Executive Director's Recommendation

PROJECT RFK Campus New Stadium Parking Garages RFK Campus, Washington, DC	NCPC FILE NUMBER 8812
SUBMITTED BY Mayor of the District of Columbia, RFK Stadium Project Management Office	NCPC MAP FILE NUMBER 8.40(49.00)46271
REVIEW AUTHORITY District Projects Outside the Central Area per 40 U.S.C. § 8722(b)(1)	APPLICANT'S REQUEST Approval of comments on concept plans
	PROPOSED ACTION Approve comments on concept plans
	ACTION ITEM TYPE Staff Presentation

RFK Campus New Stadium Parking Garages

Approval of Comments on Concept Plans

G1 Garage Options

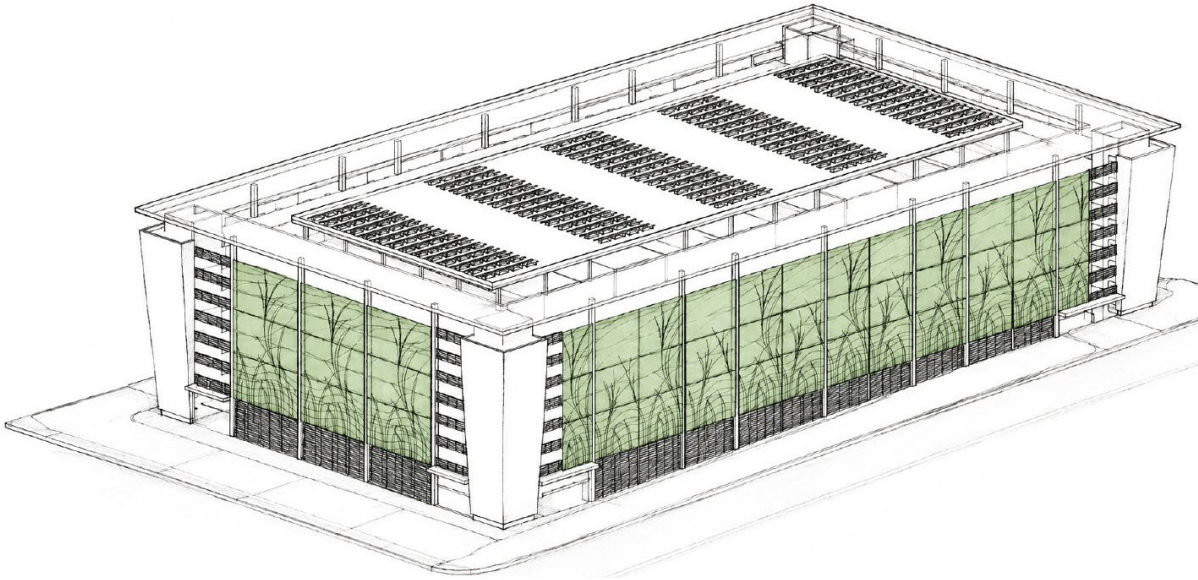
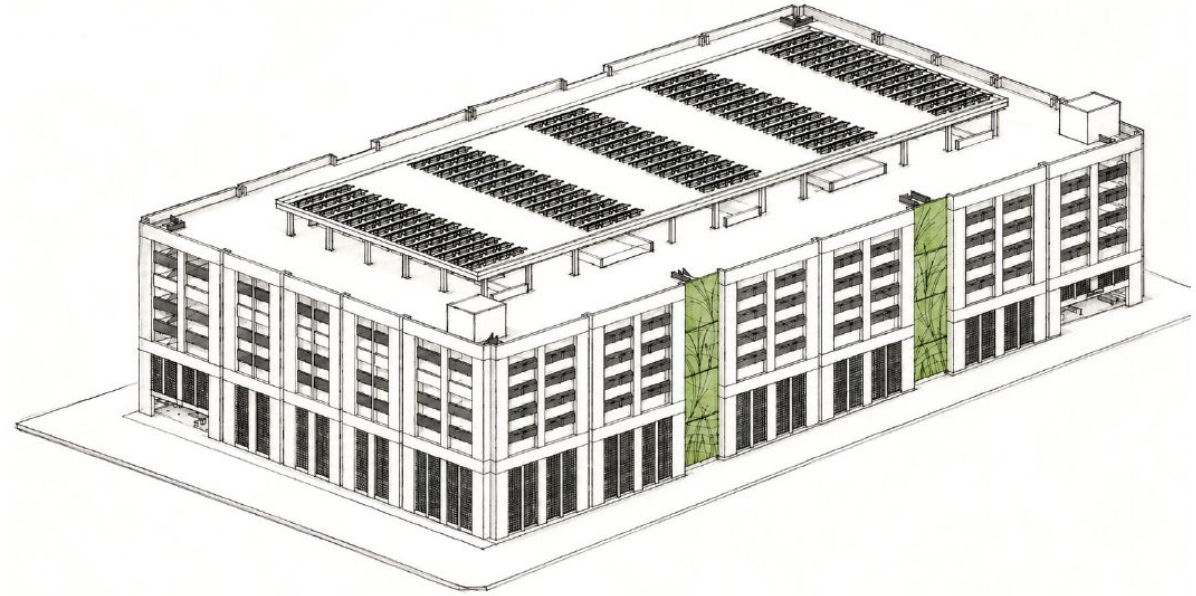
Finds Option 1 has a monumental architectural massing and character reflective of the stadium that increases the perceived scale of the garage. However, the slender perimeter columns and facade treatment add a visual lightness to the design.

Finds Option 2 includes modulated facade articulation and lower perceived height, that help to visually break down the scale of the garage. This approach aligns with the draft master plan guidance for future mixed-use development.

Recommends the applicant consider advancing an option that combines the modulation of the facade and massing of Option 2 with the lightness of the screening and detailing of Option 1.

In their discussion, the Commission members provided comments on the two alternatives presented for the facades and requested further development of both alternatives. They found that Option 2, articulated as a series of pavilions to break down its large scale, appears more aligned with the goals of the proposed master plan and would more successfully integrate into the surrounding development. They expressed appreciation for the artistic motif of native wild rice proposed for decorative panels as part of the building's cladding, and they recommended that the scale of this motif be applied consistently across the facades. However, noting that it might not be possible to incorporate the finer details on exposed concrete as proposed for the precast barriers at the spandrels, they recommended exploring alternative materials such as metal or glass panels in lieu of concrete. Finally, they recommended that the proposed light fixtures illuminate the building without themselves becoming design features; sources should be fully hidden and should avoid producing hot spots, and the interior lighting of the parking decks should be as unobtrusive as possible from the exterior.

In their discussion of Option 1, the Commission members commented that its design is visually more similar to the proposed stadium and would be more appropriate for a greenfield site, and therefore it could present a stronger architectural presence on opening day before the surrounding development is completed. However, they recommended several changes to make it more compatible with future development: adding repetitive vertical elements to break down the large facades in a similar way to Option 2; reshaping the proposed tapered corners to make them more vertical and grounded; and considering the use of uplighting for the floating roof.

[Opt. 2] Elevations

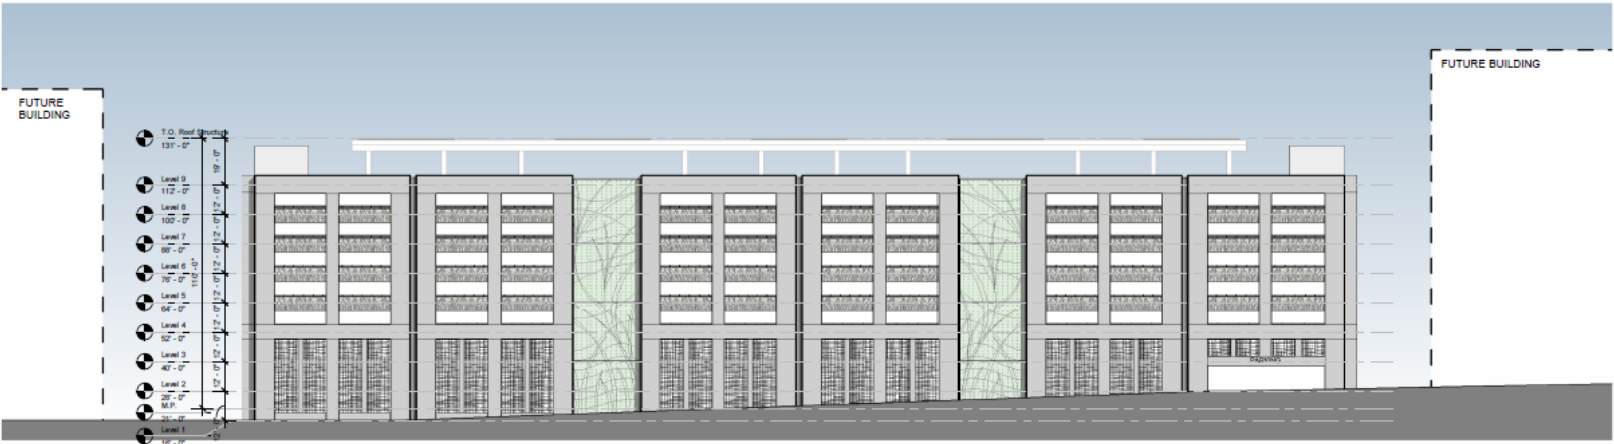
Commission find Option 2 includes modulated facade articulation and lower perceived height, that help to visually break down the scale of the garage. This approach aligns with the draft master plan guidance for future mixed-use development. Considering the elements of each option that work well in this site context, staff proposes **the Commission recommend the applicant consider advancing an option that combines the modulation of the facade and massing of Option 2 with the lightness of the screening and detailing of Option 1.**

Southeast Elevation (Stadium Side)

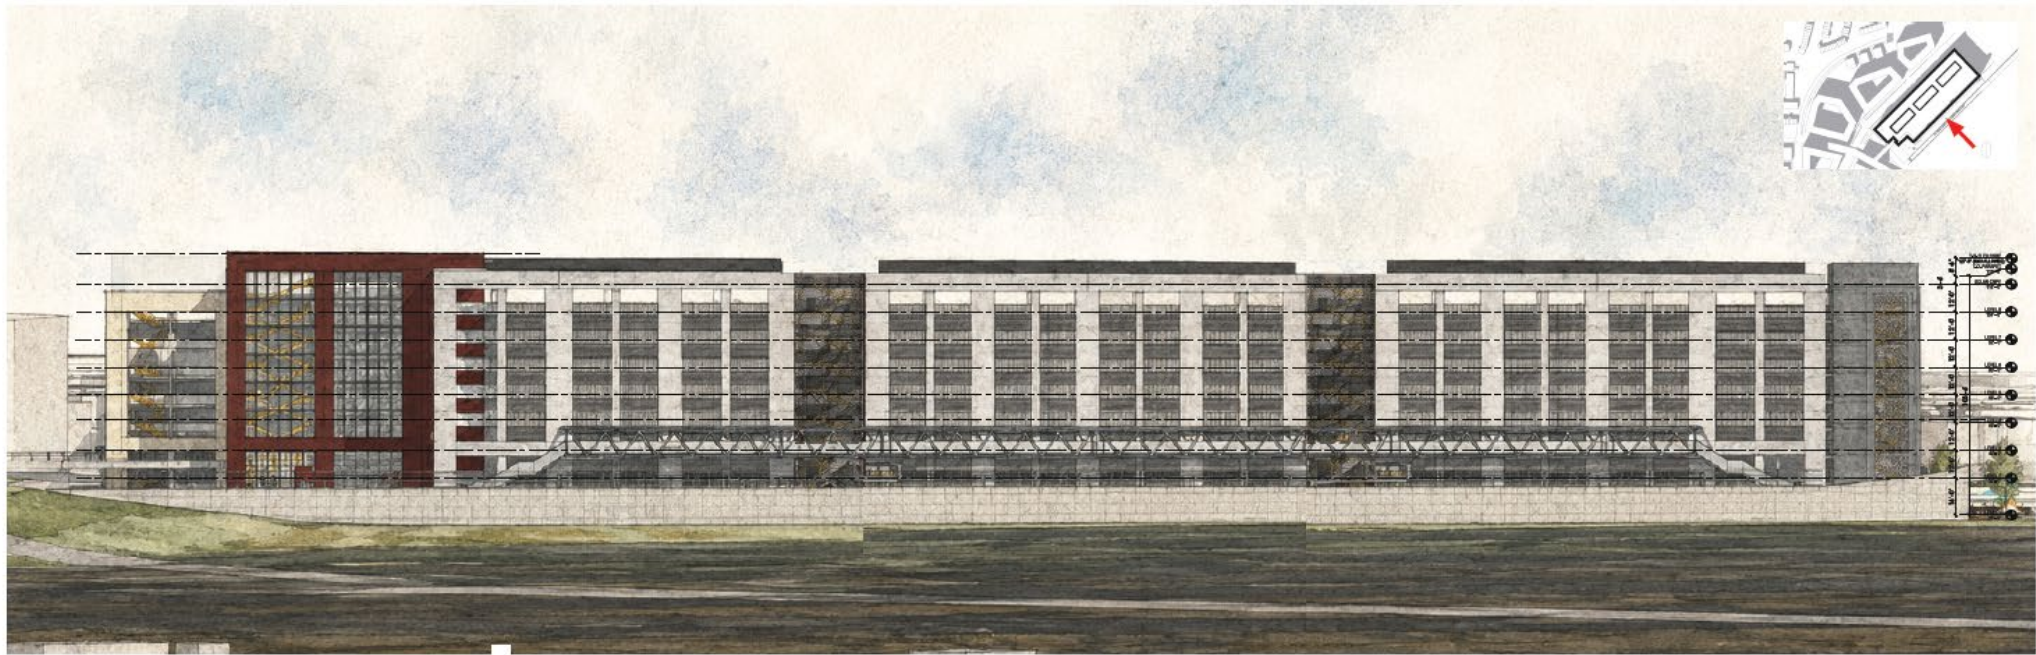
Recommends the applicant consider reducing the height of the southeast façade to decrease the perceived scale of the garage structure; and continue to refine the scale of the façade design details throughout the building.

The southeast side of the garage will still be visible after full buildout of the campus redevelopment. The design of this long facade is also modulated with larger frames that reach above the upper-level parapet on the 22nd Street side to a height of approximately 102 feet. It appears this height could be lowered without impacting the number of parking spaces, and staff suggests **the Commission recommend the applicant consider reducing the height of the southeast facade to decrease the perceived scale of the garage structure; and continue to refine the scale of the facade design details throughout the building.**

Tree Preservation and Replacement Plan

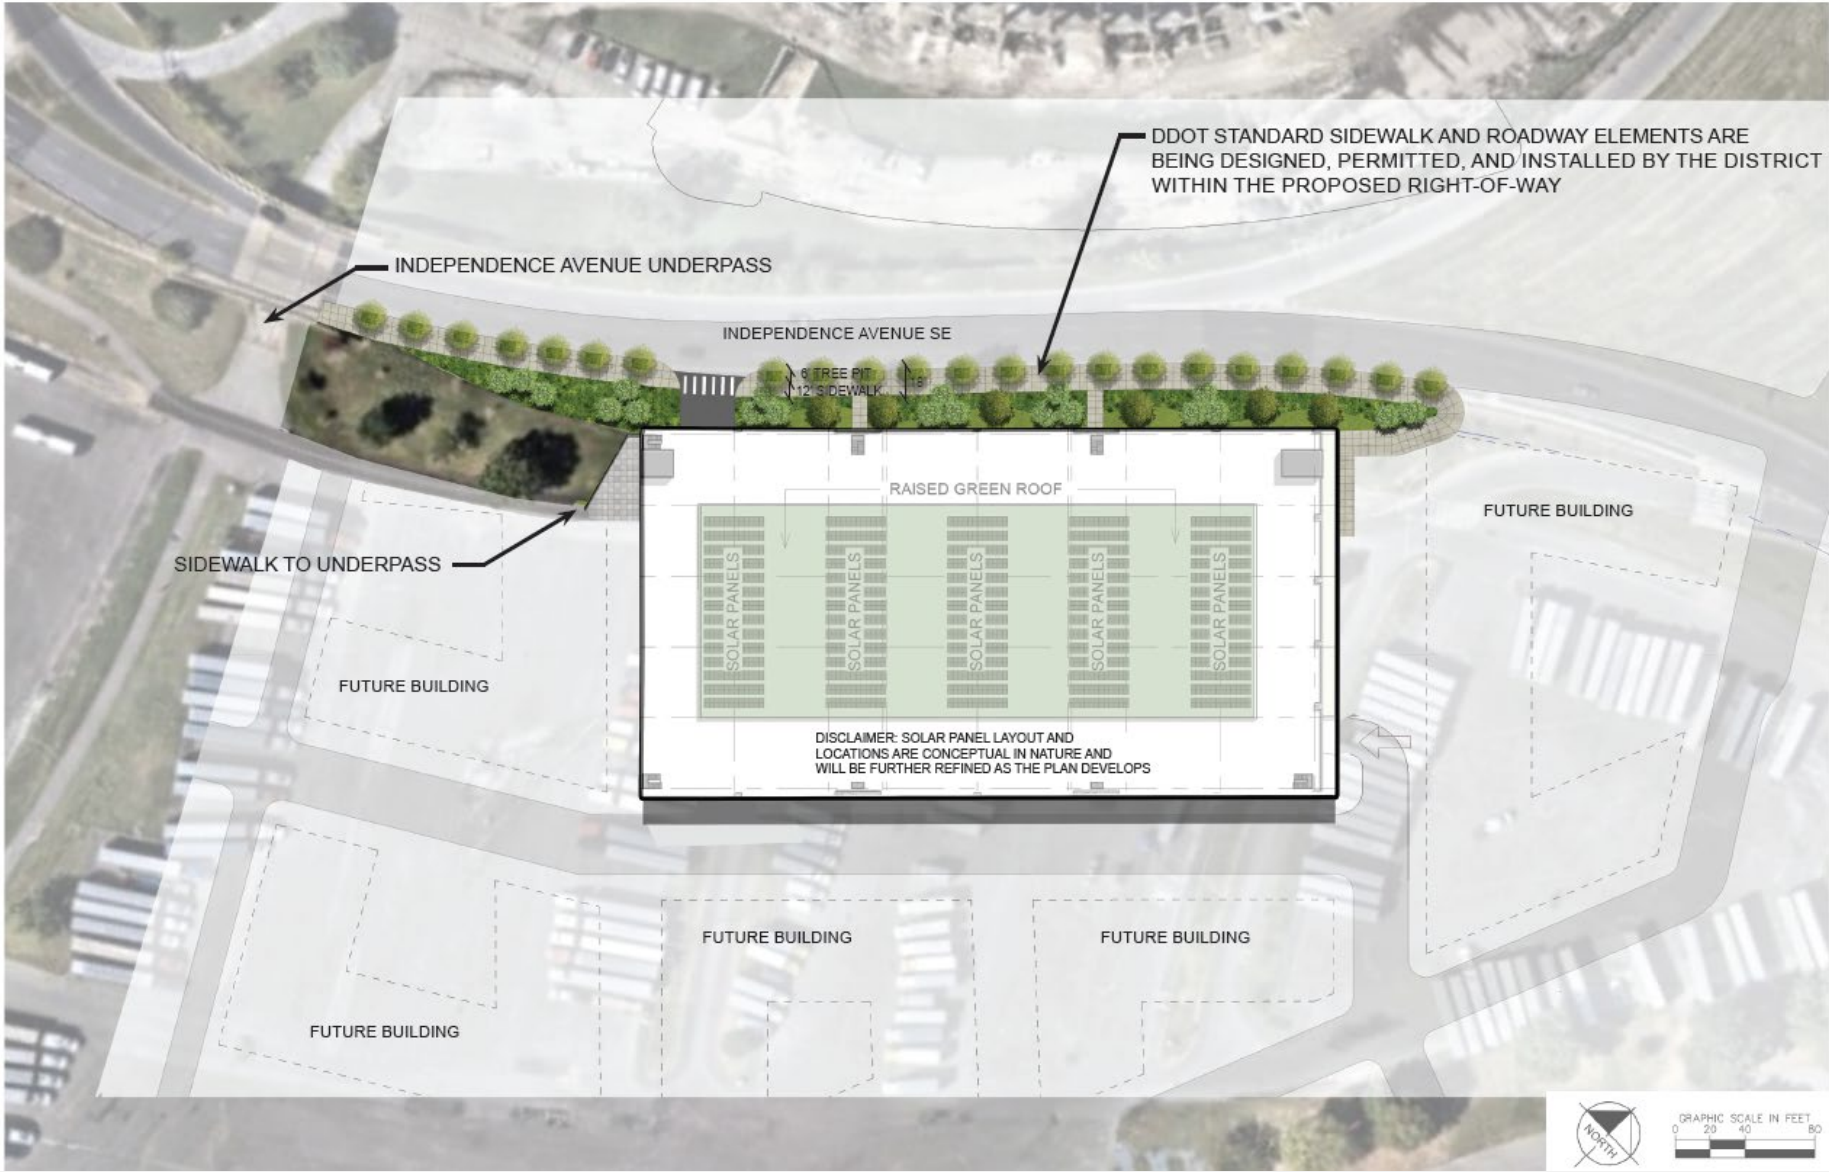
- Locations, type, and quantity of tree replacement, and conformance with District policies; and
- More detailed landscape plans for the G1 and G2 garages.

- **Locations, type, and quantity of tree replacement, and conformance with District policies; and**
- **More detailed landscape plans for the G1 and G2 garages.**
